Docket: NRC-2008-0122
Emergency Preparedness

Comment On: NRC-2008-0122-0010
Enhancements to Emergency Preparedness Regulations

NUREG/CR-XXXX "Criteria for Development of Evacuation Time Estimate Studies". Section 2.5.2 - Shadow Evacuation - pages 15 and 16. The final paragraph of this section states "population estimates for the shadow evacuation in the 10 to 15 mile area beyond the EPZ should be provided by sector." Three questions:

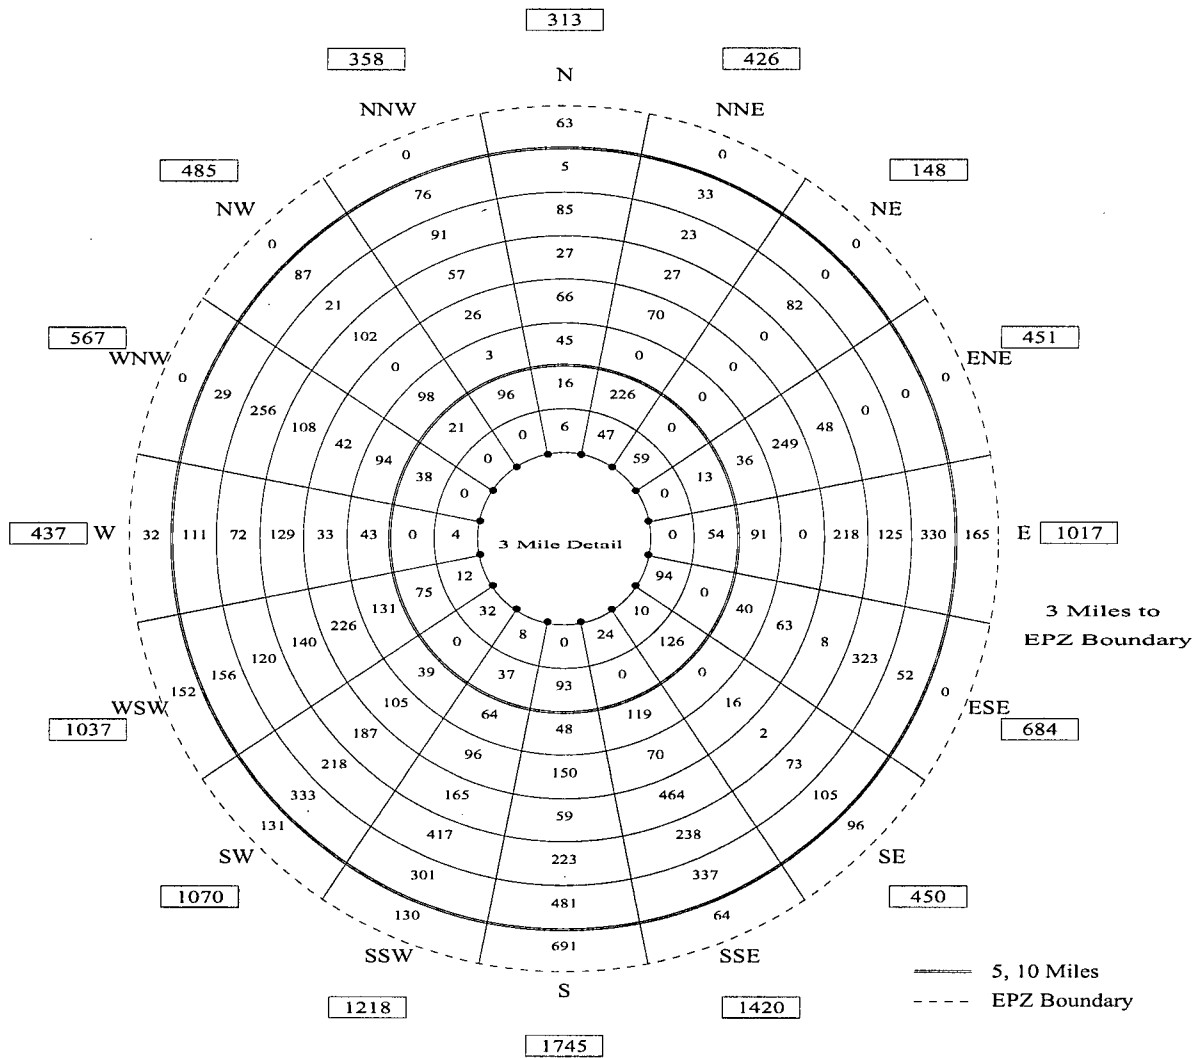
1. Figure 2-1 on page 12 of NUREG/CR-XXXX does not show sectors going beyond 10 miles. Does a separate figure similar to Figure 2-1 need to be provided showing the shadow population from 10 to 15 mile by sector?
2. Figure 2-1 shows a "10-EPZ boundary" entry in the table in the lower left hand corner of the figure, yet there is no ring beyond the 10-mile radius. Recommend including an additional ring (perhaps a dashed line) beyond the 10-mile radius so that the population beyond 10 miles, but within the EPZ boundary can be reported by sector. Also, the rectangles at the end of each sector should provide the total population for that sector. The attached file is a recommended format.
3. When reporting the shadow population by sector, should it be the actual shadow population or should the recommended 20 percent factor be applied?
